Proposed amendment to rule B. 19.1. RECOVERY POINTS

Proposed by A Reaney P&D membership secretary

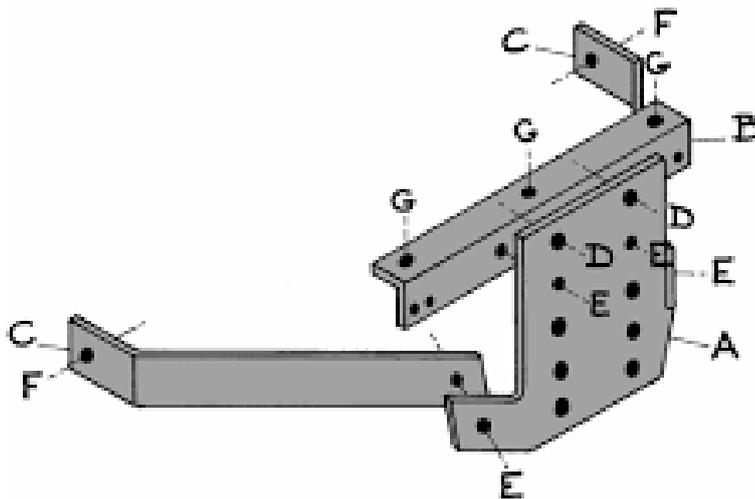
If the recovery point is bolted to a 6mm thick winch bumper or an 8mm thick drop plate does it really need a 3mm spreader behind it?

Diagram A

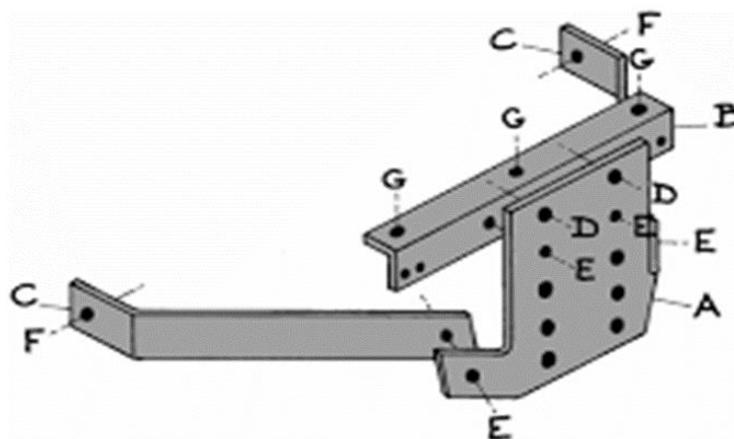
Currently there is no exemption from the 3mm spreader plate rule for any Defender however it is almost impossible to achieve this on the td5 / tdc1 chassis and goes against the design of the standard fitment.

The manufacturers design is for the tow bracket to be secured to multiple fixing points (points G, D and F in the diagram below), 7 bolts in total screwed into existing captive threads. This offers far greater strength than a standard series cross member with 2 x m16 bolts, bolted directly through the cross member even with a 3mm spreader plate on the reverse as that is still dependant on the structural integrity of the cross member and is reliant on the < 3mm steel that the cross member is made from. As opposed to the late Defender design which has the additional support from the stays attached to the fuel tank frame and the vertical bolts attached to the bottom face of the cross member.

“Where it is not possible to fit a spreader plate (such as late Defenders cross members) then any recovery point must attach using a minimum of the 7 designated fixing points (D,G,F. Diagram A) using high tensile bolts. Point F should attach to the designated points on the fuel tank frame or if not present can bolt through the longitudinal chassis rails

*Points “E” must be bolted together with high tensile nuts and bolts as per the manufacturers design. The towing attachment must **Not** be attached at point D. Tow attachments must be fitted using high tensile M16 bolts and nuts or equivalent. Drop plates / recovery systems can be shortened or purpose built provided they attach to the vehicle by the same 7 bolt method and are of equal or greater strength and design”.*
